Willy Street Proposal

Michael W. Rewey 11/30/2010

Board Members. As a former member of the Board of Public works, the Chair of the Platinum Bike Committee Infrastructure Sub-committee and consummate user of Willy Street, please consider the following. If we truly want to become a renowned biking city...

Retrofitted Commercial Avenue

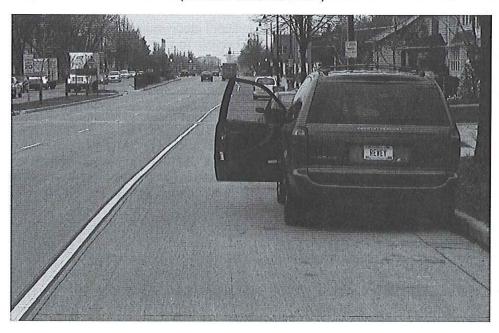
10 foot adjacent motor vehicle lane with 5 foot bike and 7 foot parking lane. (3.5 feet clear for bikes)

East Washington Avenue
11 foot adjacent motor vehicle lane with 13 foot bike/parking lane.
(4.5 feet clear for bikes)
